DOCKET: EPA-HQ-OAR-2001-0012-0774

EPA REVIEW OF DOE PEER REVIEW OF CONCEPTUAL CHANGES INCORPORATED IN THE APPA MODEL

April 2023

Figure 1 APPA BRAGFLO-DBR grid

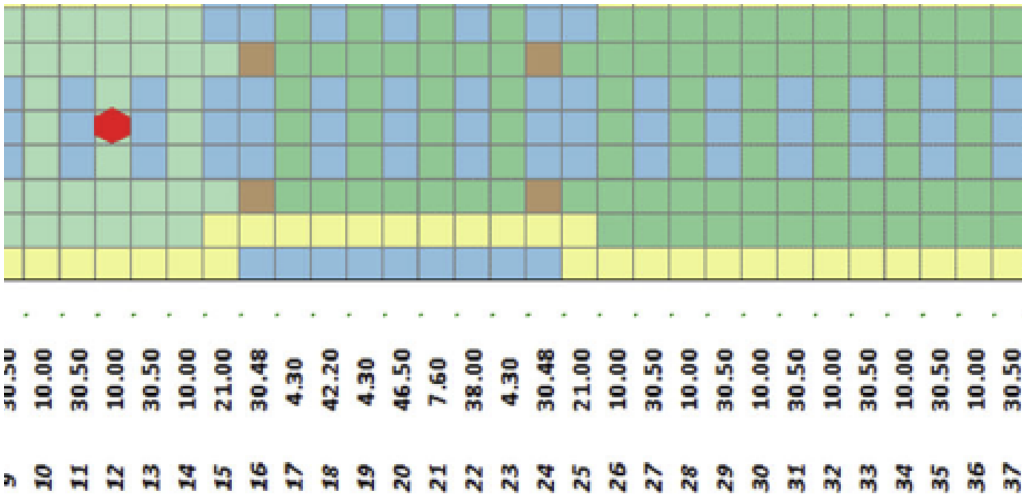
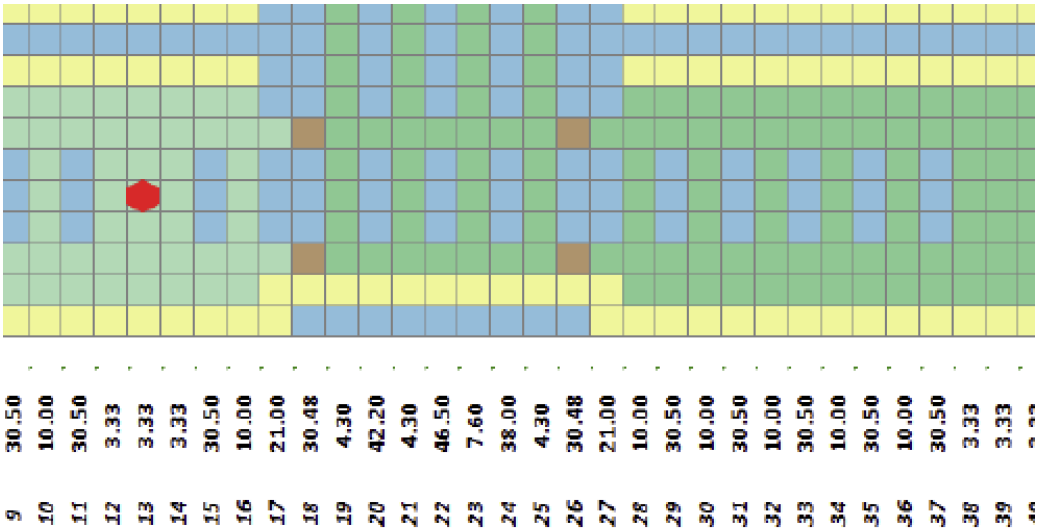
"At the request of the Peer Review Panel, King (2021e) conducted supplementary numerical simulations with a refined grid where the single column of grid cells that made up a room with a wellbore intrusion in the APPA grid was split into three columns of grid cells with the wellbore intrusion placed in the center column…" (Falta et al. 2021, p. 22).

The refined grid shown above indicates slightly higher releases than the APPA analysis for most events.

Although the small differences in releases resulted in a slight increase in mean DBR releases and in total releases at low probabilities, the refined grid results are materially the same as the coarser grid.
